### Appendix 3: Internal and External Consultee representations

Stakeholder	Question/Comment	Response																
<b>INTERNAL</b>																		
LBH Carbon Management	<p><b>Carbon Management Response 20/06/2023</b></p> <p>In preparing this consultation response, we have reviewed:</p> <ul style="list-style-type: none"> <li>• Energy Statement (BQ-WSP-XX-XX-ST-ES-0001-no_appendix_June2023) prepared by WSP (dated 13<sup>th</sup> June 2023)</li> <li>• GLA Carbon Emission reporting spreadsheet dated May 2023</li> <li>• HGY-2023-0261 Berol Quarter N17 – May response to the comments from CMT</li> <li>• Noise and Vibration Assessment prepared by WSP (dated December 2022)</li> <li>• Relevant supporting documents.</li> </ul> <p><b>1. Summary</b></p> <p>The development achieves a reduction of 72% carbon dioxide emissions. This increase in on-site savings is supported in principle. Some clarifications must be provided with regard to the Overheating Strategy. Appropriate planning conditions have been recommended to secure this which includes some outstanding requests for information.</p> <p><b>2. Energy Strategy</b></p> <p>The applicant has amended the carbon reduction values in the repo

Figure 6-12 Interim Car Parking Provision

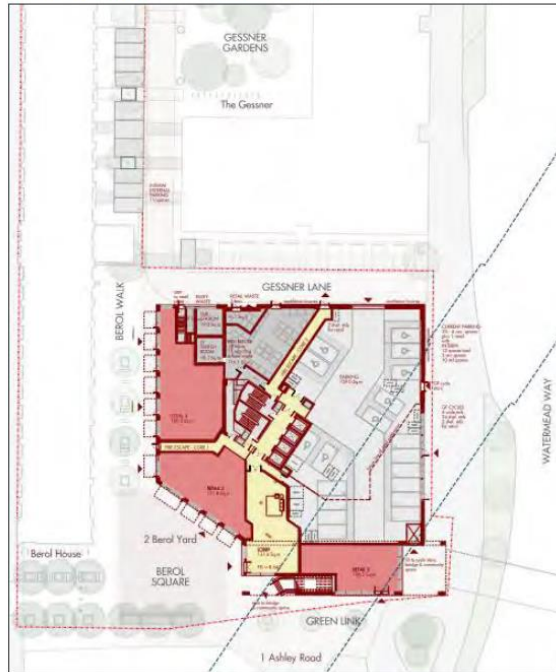
- c. Regarding Figure 6.12 and Figure 6.6 – Are the car parking spaces and the cycle parking both at ground floor levels or different levels?
- d. Regarding provision of Club bays, the current proposals are significantly different from those previously considered under Planning Ref: HGY/2017/2044. The TAR should assess / review the existing and committed demands for car club vehicles and demonstrate adequacy of provision of car club vehicles / capacity, to service the cumulative demands including from additional residential development proposals. A detailed proposal will be required.

Clarification is required regarding the overlaps in layout of interim retained 30 car parking in Fig.6.12, the cycle parking illustrate at Figure 6.6 and the vehicular swept path for a refuse vehicle, below.
